CERTIFICATE OF APPROPRIATENESS**Application Date:** Feb. 1, 2024**Applicant:** Valere Costello, owner

Property: 443 Columbia Street, Lot 2, Block 304, Houston Heights Neighborhood Subdivision. The property includes a historic 780 square foot, one-story wood single-family residence situated on a 6,600 square foot (50' x 132') interior lot. An addition of 851 sq. ft. was constructed in 1998 increasing the total square footage to 1,631 sq. ft.

Proposal: Alteration: Second-Story Addition

Recommendation: Denial - does not satisfy criteria
Design Guidelines

HEIGHTS DESIGN GUIDELINES MEASURABLE STANDARDS**S D NA****S - satisfies D - does not satisfy NA - not applicable**☒ ☐ ☐**Maximum Lot Coverage (Addition and New Construction)**

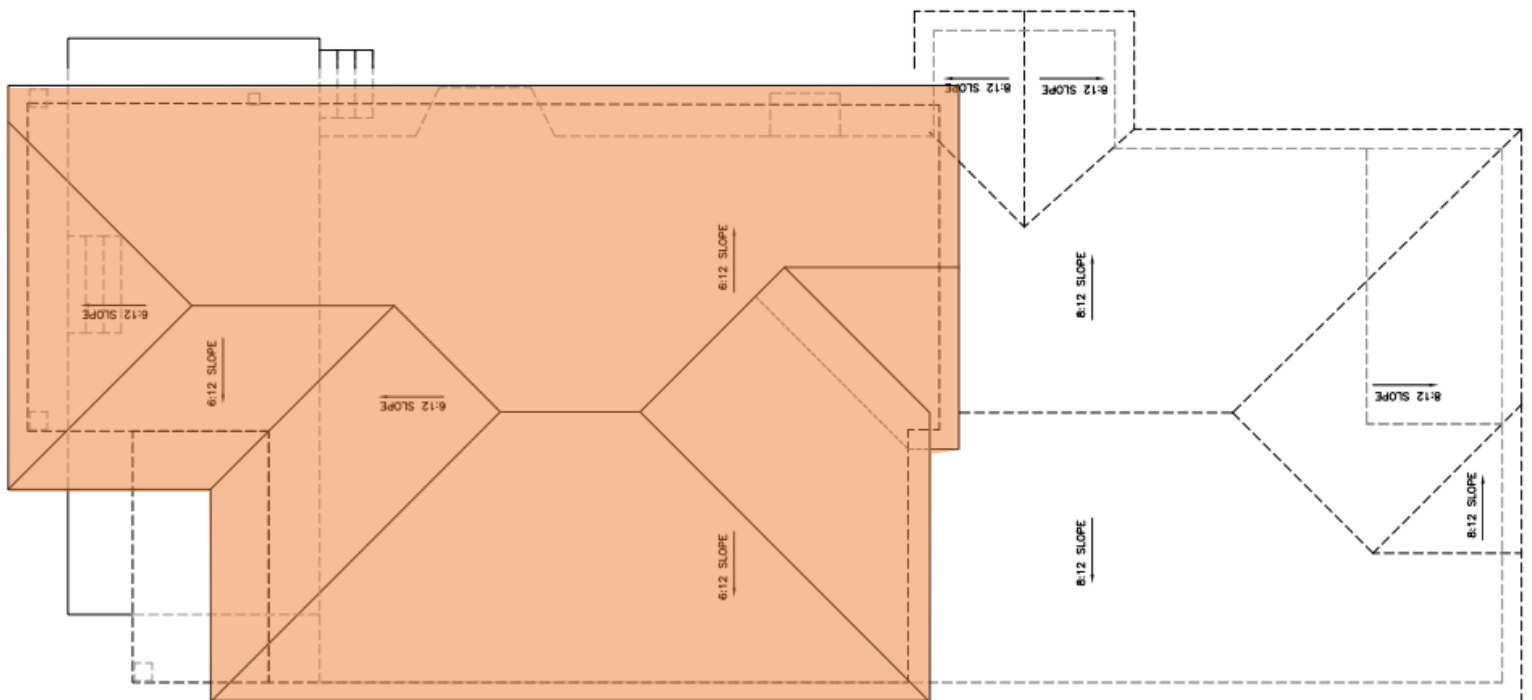
Remaining Amount: 1,027 ****without** sq. ft. below conditioned space**Proposed Lot Coverage: 2,003 ****with** sq. ft. below conditioned space**Remaining Amount: 1,027 ****with** sq. ft. below conditioned space**☐ ☒ ☐**Maximum Floor Area Ratio (Addition and New Construction)**

Remaining Amount: 70 ****without** sq. ft. below conditioned space**Proposed FAR: 3,224 ****with** sq. ft. below conditioned space**Remaining Amount: 320 ****with** sq. ft. below conditioned space**

Side Setbacks (Addition and New Construction)

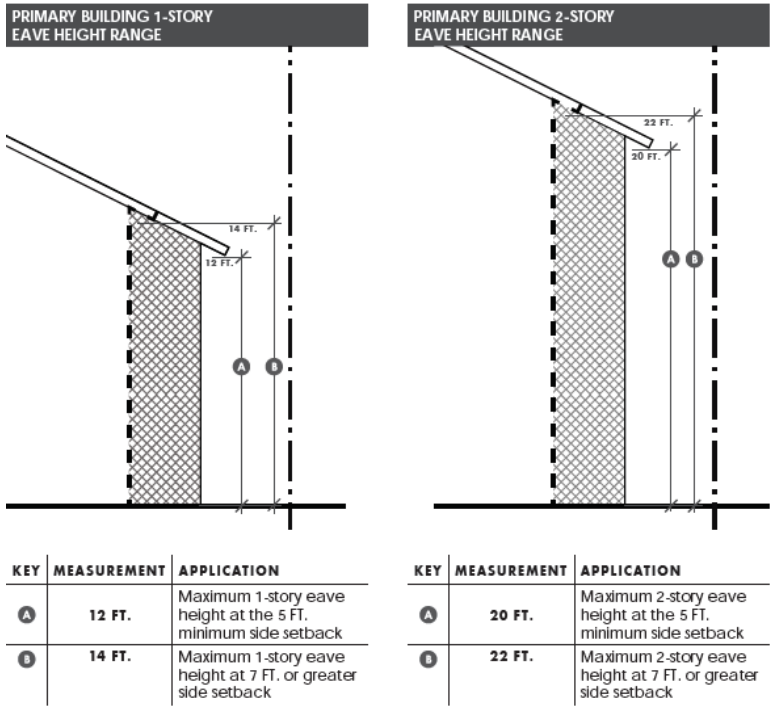
Proposed North side setback (1): 5' 0"Proposed South side setback (2): 15' 1"Cumulative side setback: 20' 1"
